REZONING &

SUBDIVISION STAFF REPORT Date: August 5, 2004

SUBDIVISION NAME Government Street Highland Subdivision, Resubdivision of

LOCATION 254, 256 and 260 Dogwood Drive

SITE PLAN

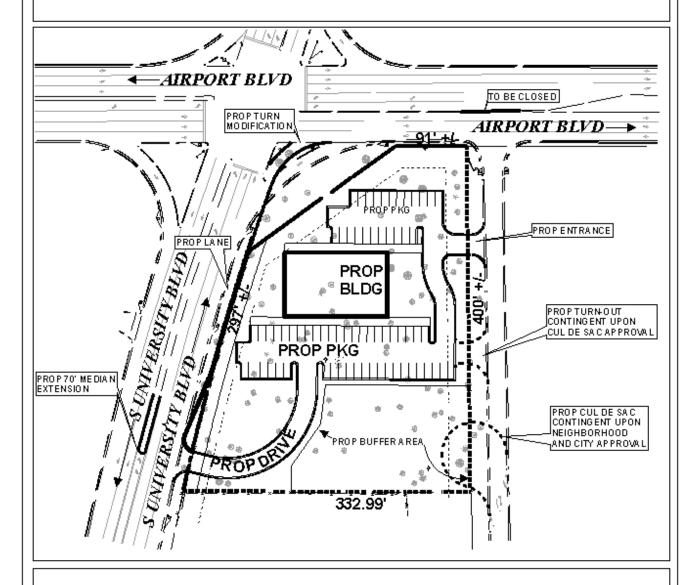
COMMENTS Request dedication of 25-foot radius at intersection of Dogwood Dr. and Airport Blvd. Must comply with all stormwater and flood control ordinances. Any work performed in the right of way will require a right of way permit.

<u>COMMENTS</u> Driveway number, sizes, location and design to be approved by Traffic Engineering and conform to AASHTO standards.

Additionally, access as proposed would be less of a hazard than the allowance of a curb cut to Airport Boulevard. Typically, access to a minor residential street such as Dogwood Drive would not be desirable; however, given the alternatives, the location of a driveway on Dogwood Drive, a safe distance from Airport Boulevard, would be the least problematic.

The site plan submitted exceeds requirements for landscaping and retains many of the existing trees on site. While some trees will have to be removed, those are predominately in the center of the site and not along the perimeter. Also, a large landscaped buffer, which exceeds Zoning Ordinance requirements, is to be provided along the South property line. The plan does not indicate the provision of a sidewalk along all street frontages; however, unless a sidewalk waiver is requested and approved, sidewalks will be required. Because some portions of the sidewalk

RECOMMENDATION Rezoning: based on the preceding, it is recommended that this application be approved subject to the following conditions: 1) dedication and construction of the redesigned turn lane as reflected on the site plan submitted, exact design to be approved by Traffic Engineering; 2) construction of median modifications as reflected on the site plan submitted, exact design to be approved by Traffic Engineering; 3) completion of the accompanying subdivision application; 4) provision of a 6' (minimum) privacy fence or wall and a 25' (minimum) landscaped buffer along the South property line, with the exception of the drive from University Boulevard; 5) provision of screening of parking in compliance with Section VI.A.3.i for the entire Dogwood Drive frontage, with the exception of the 45' setback from Airport Boulevard for the visibility triangle (Section IV.D.4); and 6) full compliance with all municipal codes and ordinances.

Subdivision: the plat meets the minimum requirements of the Subdivision Regulations and is recommended for Tentative Approval subject to the following conditions: 1) dedication and construction of the redesigned turn lane as reflected on the site plan submitted, exact design to be approved by Traffic Engineering; 2) construction of median modifications as reflected on the site plan submitted, exact design to be approved by Traffic Engineering; 3) dedication of a 25' radius at the intersection of Dogwood Drive and Airport Boulevard; 4) placement of a note on the final plat stating that the site is limited to one curb cut to University Boulevard, location and design to be approved by the Traffic Engineering Department; 5) placement of a note on the final plat stating that the site is limited to one curb cut to Dogwood Drive, location and design to be approved by the Traffic Engineering Department; and 6) provision of sidewalk easements and hold harmless agreements for those portions of sidewalks that may be provided on the private property.
